Variance Report

Case #AV25-0010

Project Name	6388 E 78 th Avenue Attached Carport Variance
Location	6388 E 78 th Avenue
Site Size	0.04 acres
Current Zoning	PUD (Planned Unit Development)
Applicant	Joseph Rubio
Property Owner	Joseph Rubio
Case Planner	Omar Yusuf

Figure 3. Site Plan

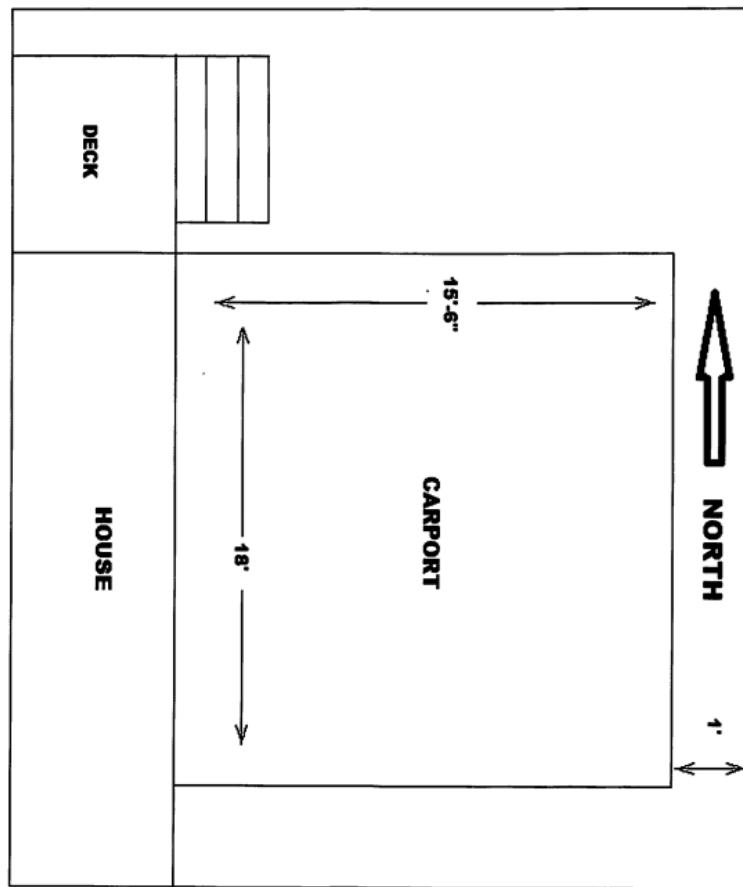
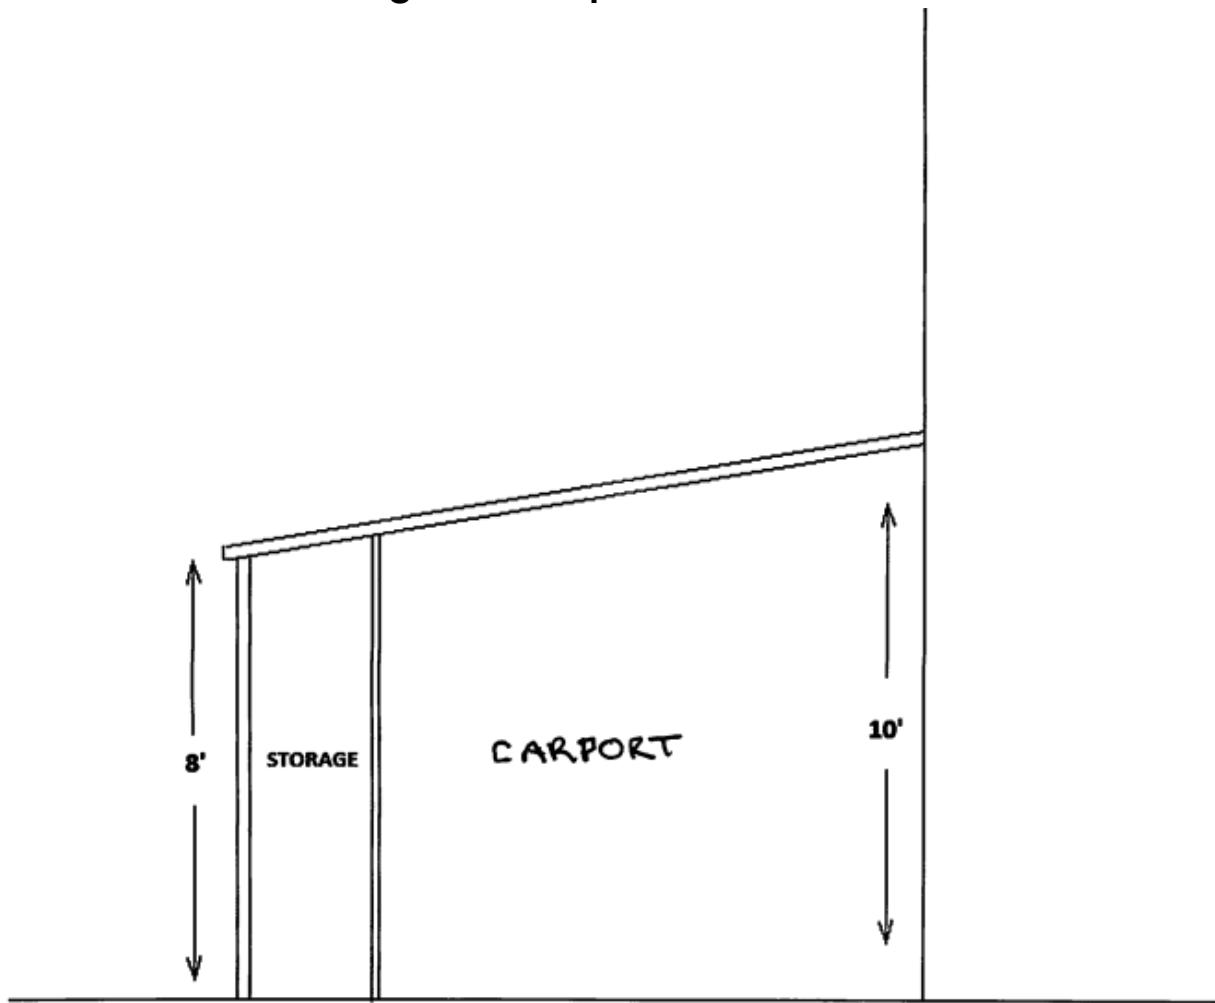
The property owner, Joseph Rubio, is requesting a variance to reduce the 5-foot setback from the front of the house to a 0-ft setback, a 5-foot reduction for a proposed attached carport (Figure 3).

Analysis: Since most residential properties in the city adhere to the accessory structures bulk standards, the current footprint of the attached carport does not encroach past the front façade of the home and is at least 20-ft from the right-of-way. The carport on the property is totally within the side yard of the property and does not encroach into required right-of-way access and obscured by the principal structure which screens it from view of adjacent properties. Additionally, there are no adverse effects to adjacent properties. ***Therefore, it can be found that this application meets criteria (iii).***

Planning staff has found that the application does not meet the approval criteria found within [Sec. 21-3222\(3\)](#) of the Land Development Code, and therefore the Planning Division **does not** recommend the Board of Adjustment approve case AV25-0010.
